Work Order ID 64244

DESIGN #	DRAWN BY CP	DART AEROSPACE LTD HAWKESBURY, ONTARIO, CANADA	
CHECKED #	APPROVED #	DRAWING NO. D3166	REV. A SHEET 1 OF 1
DATE 02.07.10		TITLE BASKET HOOP	SCALE NTS
A	02.07.10	NEW ISSUE	
A1	04.04.08	38+/-1 WAS 36.0

DRAWING NO. D3166	TITLE BASKET HOOP	REV A1	DART AEROSPACE LTD ENGINEERING ORDER		D.E.O. NO. D3166-A-2	SHEET NO. 1 OF 1	SCALE NTS
DRAWN AJS	CHECKED <i>[Signature]</i>	MFG. APPR. <i>[Signature]</i>	APPROVED <i>[Signature]</i>		DE APPR. <i>[Signature]</i>		
DATE 08.12.11	DATE 08.12.15	DATE 08/12/15	DATE 08/12/16		DATE 08.12.16

D3166-1 BASKET HOOP

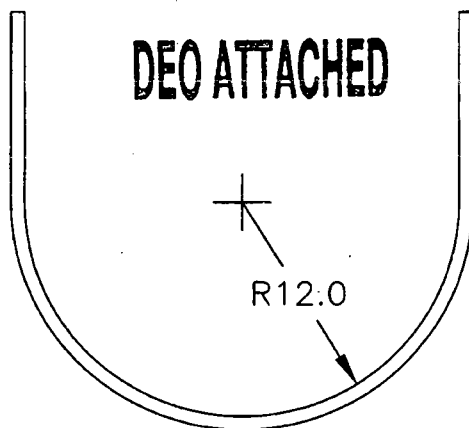
1) MODIFY MATERIAL NOTE FOR D3166-1 AS SHOWN:

WAS:

1) MATERIAL: AISI 304/316 SS SQUARE TUBING,
0.75" x 0.75" x 0.063 WALL, 60.00" LONG
(REF DART SPEC. M304TS0.750W.063)

IS:

1) MATERIAL: AISI 304/316 SS, 3/4 X 3/4 X 0.065 WALL SQUARE TUBING,
60.00" LONG
REF. DART SPEC M304TS0.750W.065

D3166-3 BASKET HOOP

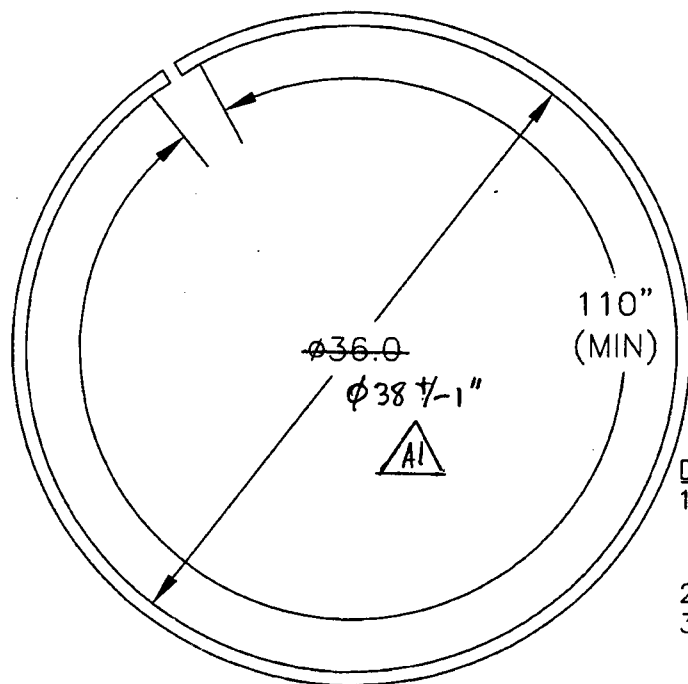
2) MODIFY MATERIAL NOTE FOR D3166-3 AS SHOWN:

WAS:

1) MATERIAL: AISI 304/316 SS SQUARE TUBING,
0.75" x 0.75" x 0.063 WALL, 120.00" LONG
(REF DART SPEC. M304TS0.750W.063)

IS:

1) MATERIAL: AISI 304/316 SS, 3/4 X 3/4 X 0.065 WALL SQUARE TUBING,
120.00" LONG
REF. DART SPEC M304TS0.750W.065
